Studebaker

SERVICE BULLETIN

NO. 312

1956

FIG. 1

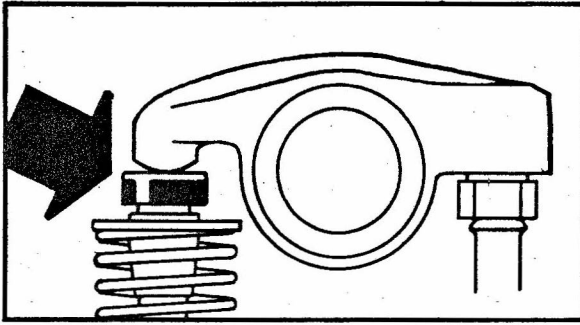
A special valve stem cap for V8 engines has been made available for service. It may be used in correcting cupped valve stem ends, which result in excessive valve noise and inaccurate settings, without grinding stem ends. It is not necessary to disassemble the rocker assembly to install them. Loosen the rocker arm bracket screws and cylinder head cap screws that hold the rocker assembly to the head, and insert the special valve stem cap. Retighten

The valve stem caps should be installed in complete sets. The caps are available from the Parts and Accessories Division through your Parts Depot under Part No. 536426. Sixteen are required per car.

FIG. 2

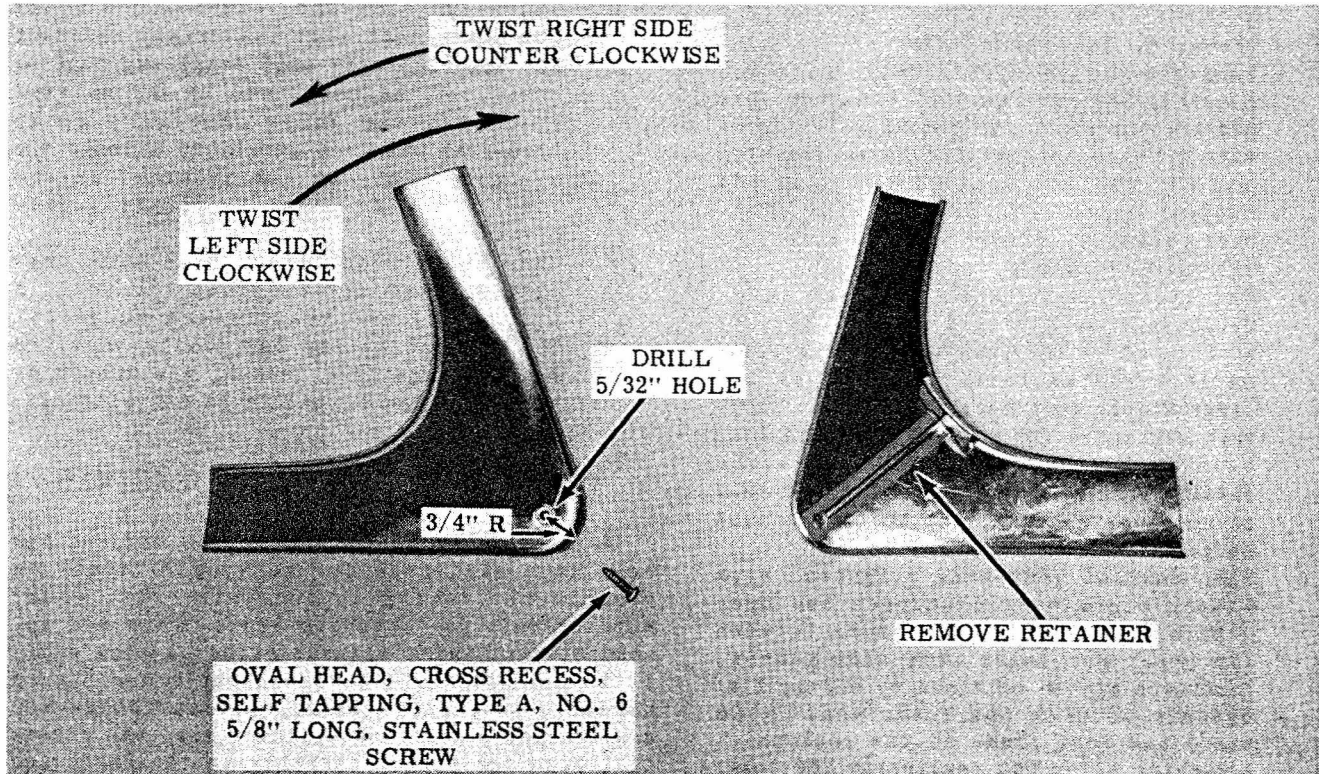
Remove the corner moulding retainer section from the weather seal, top and lower mouldings. Remove and discard the retainer from the corner moulding. Twist the upper section of the moulding to obtain approximately 1/2" set. Right side - twist counter-clockwise. Left side - twist clockwise. Locate and drill a hole at the center of a 3/4" radius on the corner moulding as shown (Fig.2) and carefully countersink the hole.

FIG. 3

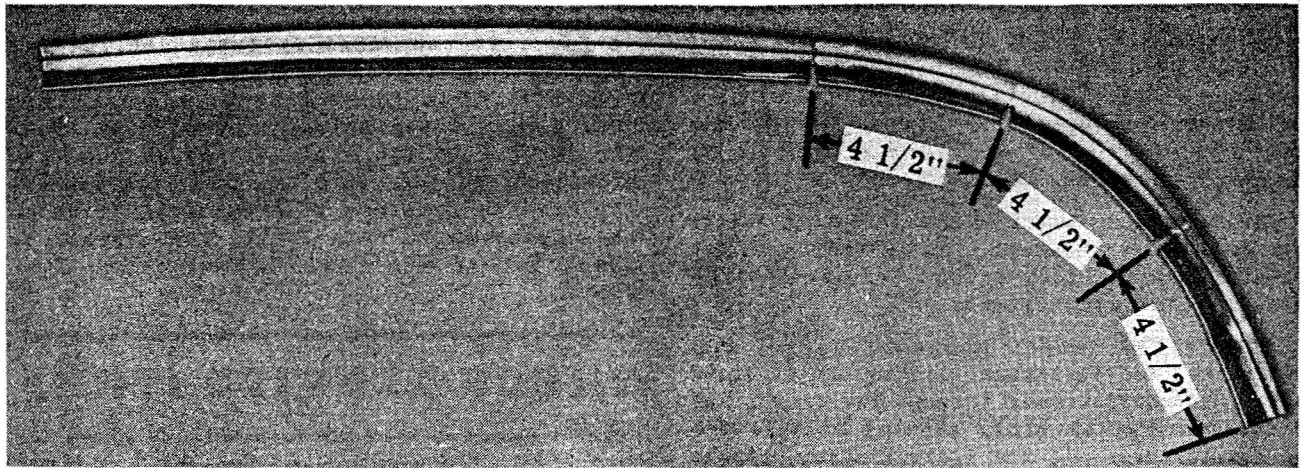
Cut three slits as deep as possible, in the top moulding retainer section then cut each side of the slit to form a notch all the way to the bottom of the retainer at 4-1/2" intervals as shown in Fig. 3.

FIG. 4

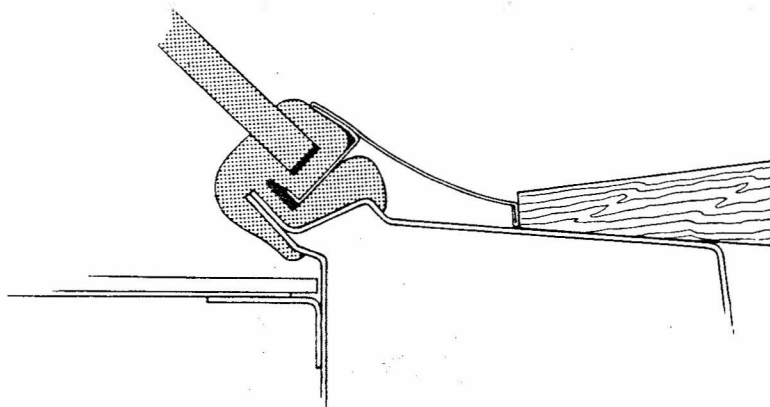
Where the bottom moulding does not fit down to the deck lid panel, leave the moulding installed in the seal, and holding the moulding firmly against body panel with both hands, one on each side of gap, have a helper use a piece

of fibre or hard wood placed on the lower side of the moulding flange. Move moulding up toward glass by tapping lightly against the fibre or wood block. (See Fig. 4.) Extreme care must be taken not to distort the moulding. (Protect the painted area against damage.)
